PART 1 - Draft Semaphore Foreshore Masterplan Report

Semaphore Foreshore Masterplan Early Engagement Summary Report

28 July 2022

Figure 2 - Draft Semaphore Foreshore Master Plan

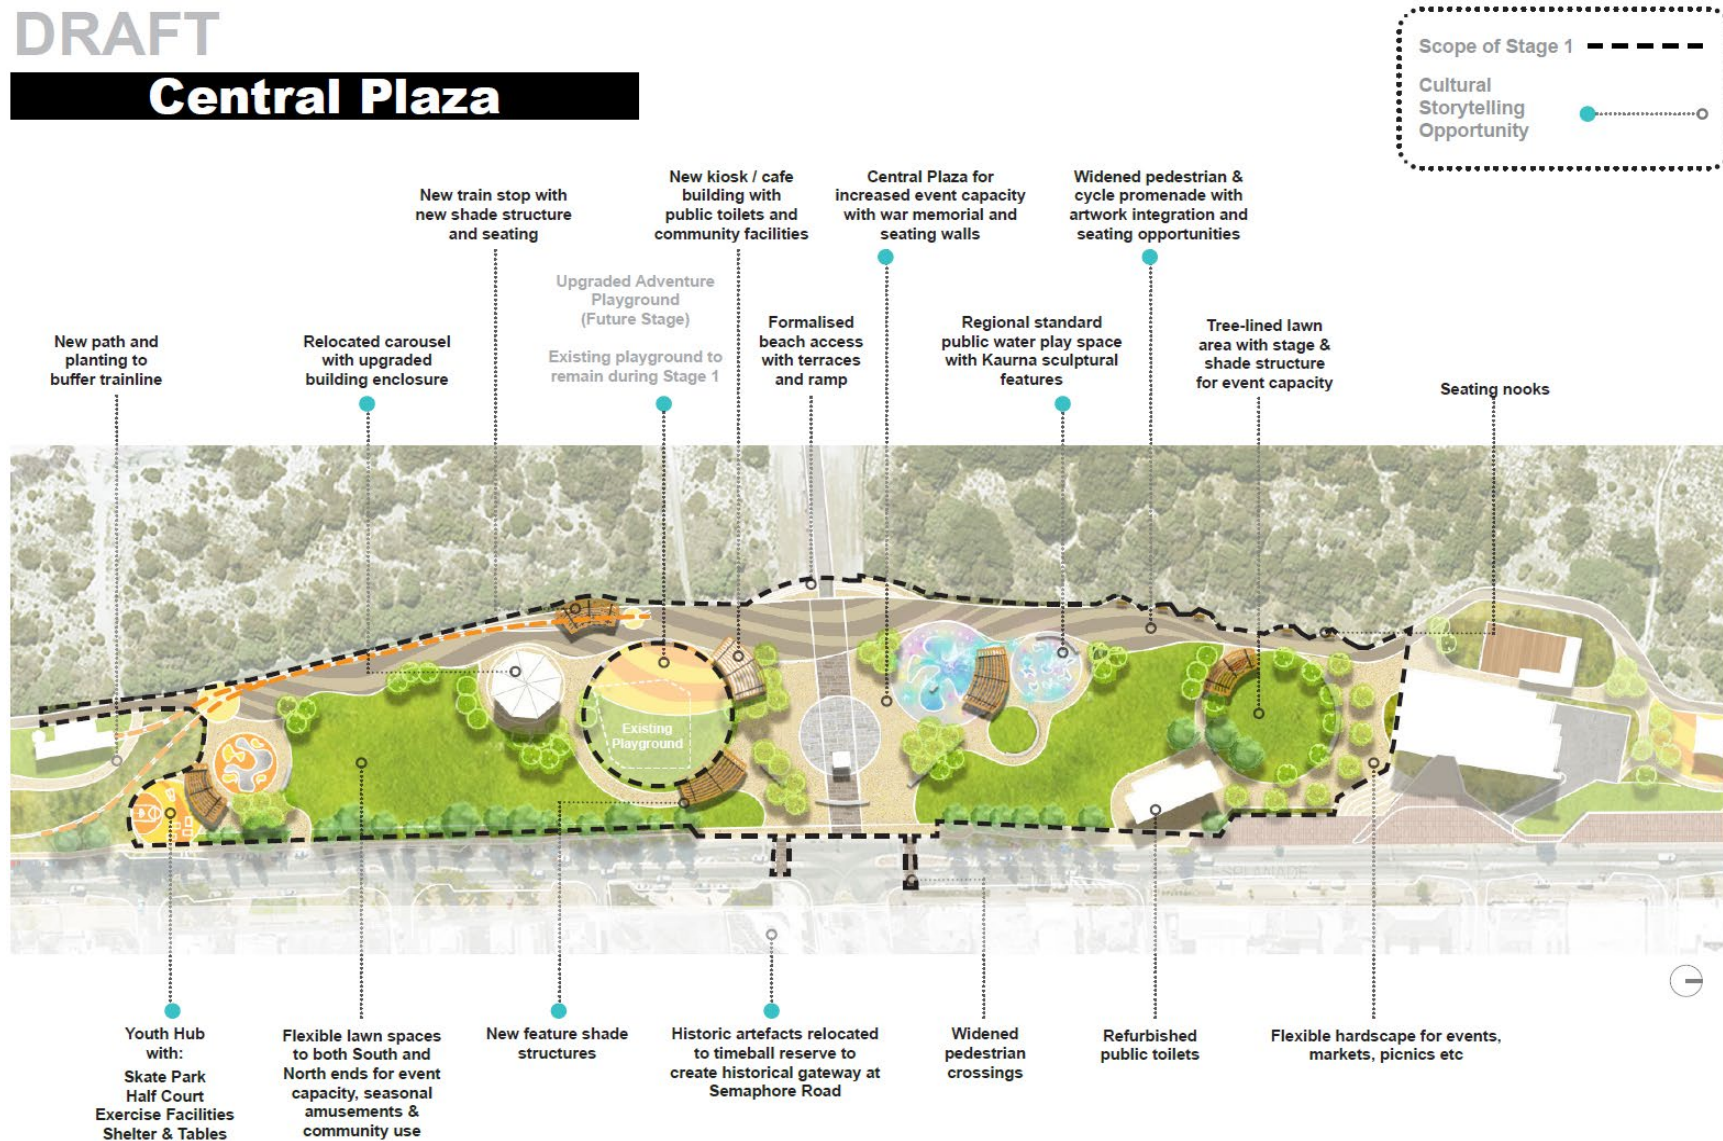
- People love open green spaces. Suggestions to **reduce paving/concrete** (too hot) and **provide lots of lawn space** for play, picnics, social gatherings, and event footprints

- People love trees and want more shade. They want more **natural shade** (trees particularly to the west and consider natives or fast-growing species) and more sun and rain proof **shelters** over seating and play areas. Increase **seating and picnic tables** and consider use by larger groups

- Mixed views on location of **amusements**. Comments suggested moving the amusements to the south, but some wanted them to stay where they are. Multiple comments were made questioning the place of the amusements at the Foreshore at all due to cost to play, mis-matched atmosphere and concerns with safety from anti-social behaviours

- People love that the **carousel** is included and would like it to remain in its current location. People are concerned at the risk or cost of moving it. View into the carousel could be improved (e.g. clear walls)

- People are concerned about **parking** demand increasing. Some suggested **alternative transport** such as better public transport connection or a free community shuttle bus. Making the esplanade one way was suggested to provide more angle parking

Main plaza

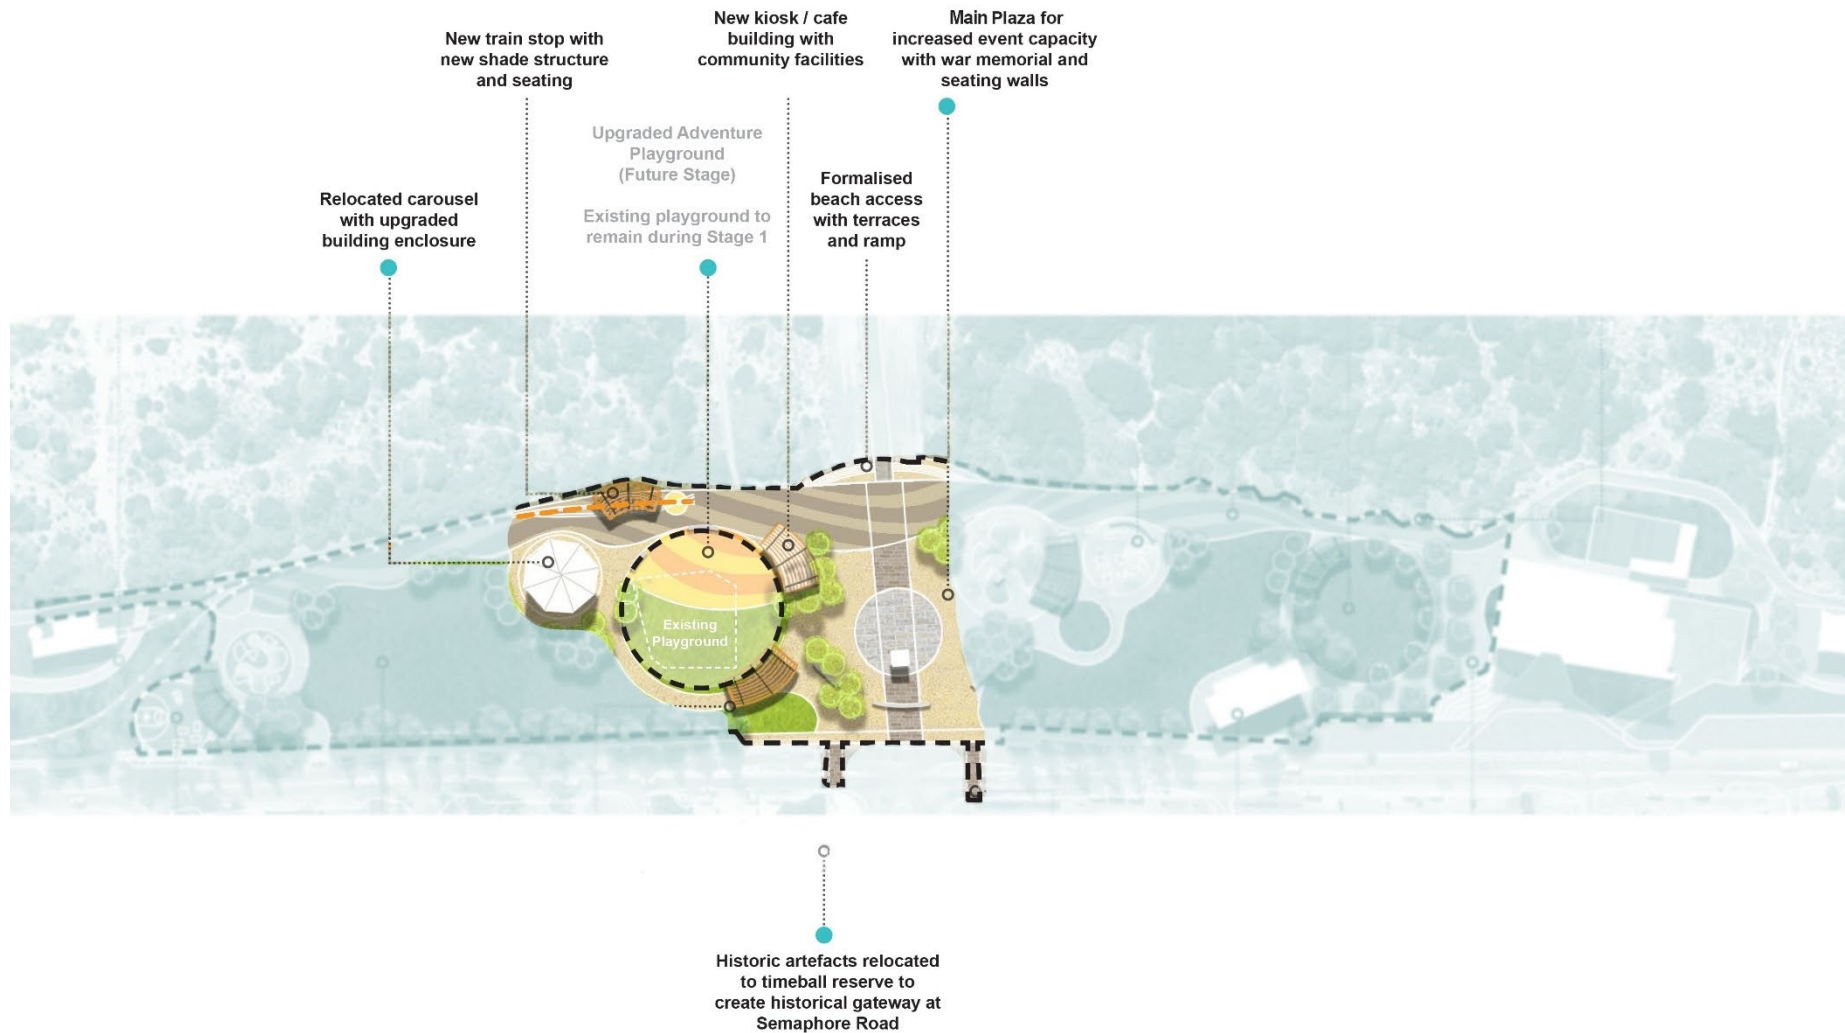
“I am opposed to the removal from the site of the large rectangular shelter shed. This shelter is used a lot by many families and the large size of it makes it useful in providing effective shelter in wet weather, something which the numerous proposed shelters with slats will not provide”

“The space is bland & does not provide additional amenity for residents, visitors & tourists”

More seating was a commonly suggested improvement. Other suggestions included more trees and low plantings, multiple showers, a bigger kiosk, paid lockers, a splash pool, a barrier between the Main Plaza and the road edge, and bike locking amenities. Several respondents suggested "paring back the size of the water play area and providing more seating / relaxation spaces and other amenities".

Water play space & Kaurua story telling in water play

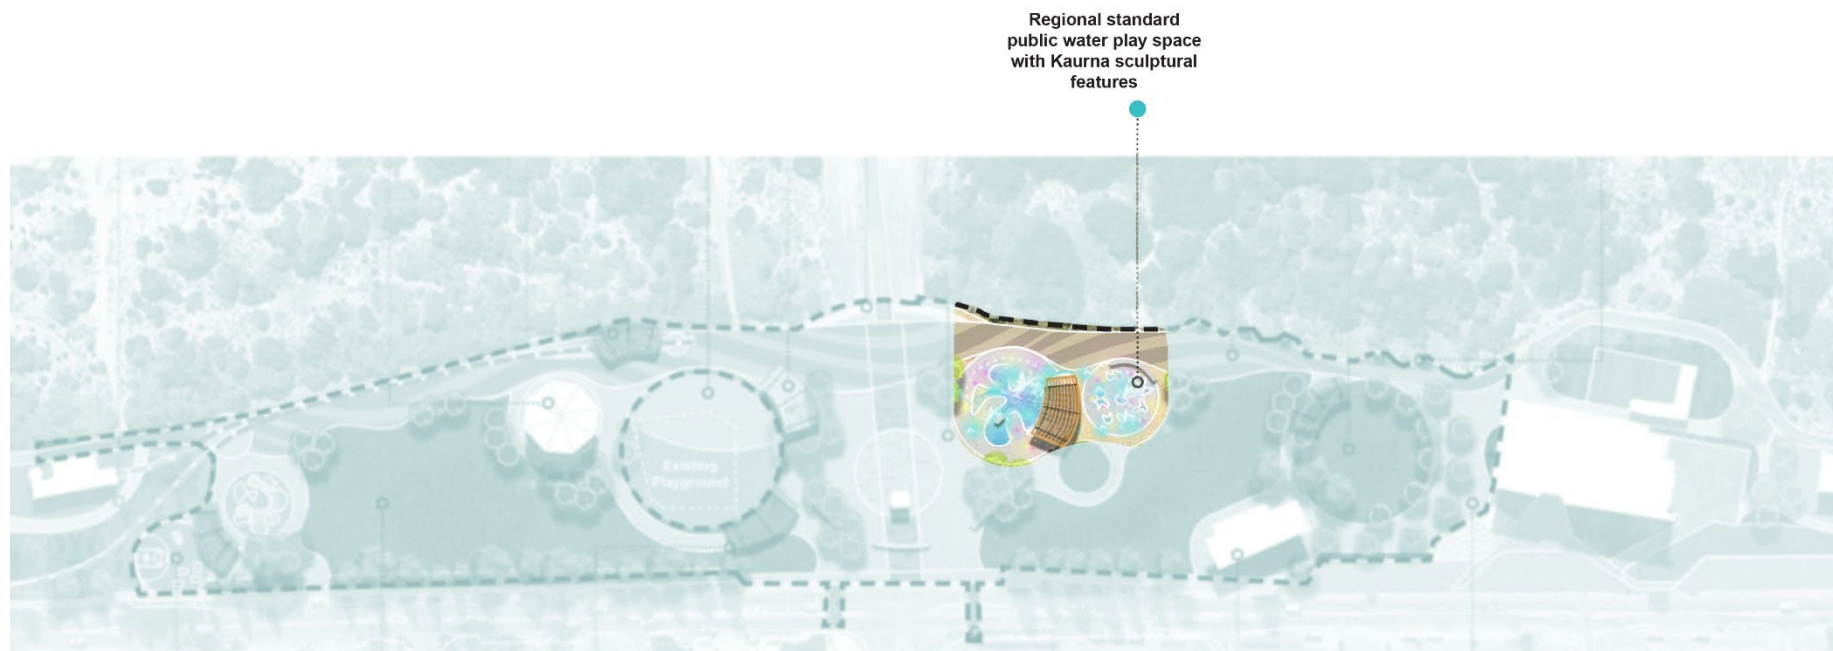
One of the most common suggestions to improve the waterplay space was to provide additional shade and seating. Comments included:

"I love it. Only question is whether the shade structure displayed provides shade, it looks like there are gaps between the slats and so will not provide proper, weatherproof shade"

"The plan looks like a concrete jungle"

**Youth Hub
with:
Skate Park
Half Court
Exercise Facilities
Shelter & Tables**

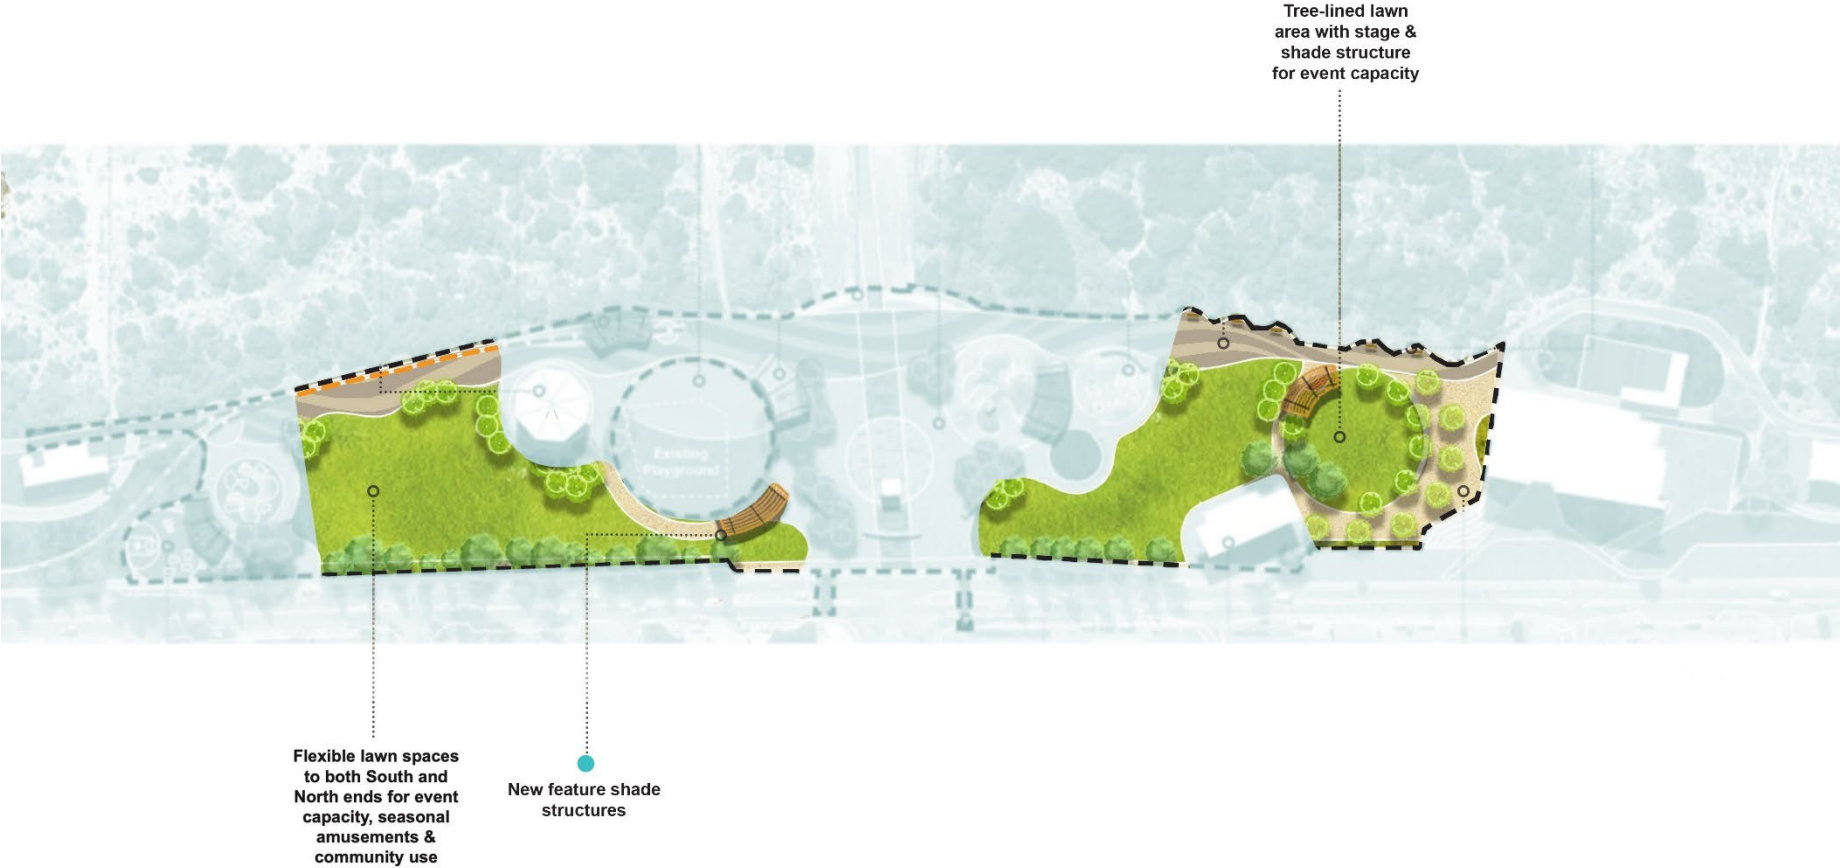
Many respondents suggested additional features that could be added to the proposed design. More seating, more exciting skate park features and equipment that caters to all ages/people were common suggestions:

"I question the exercise facility - the one at Largs Bay seems to get little use. Could there be better use of space? Climbing equipment? Something to build upper body strength like a flying fox?"

Several respondents questioned the need to replace the current skate park:

"The existing skate park is in a good location and there is ample room to build onto or add another ramp etc south of it, including the basketball court"
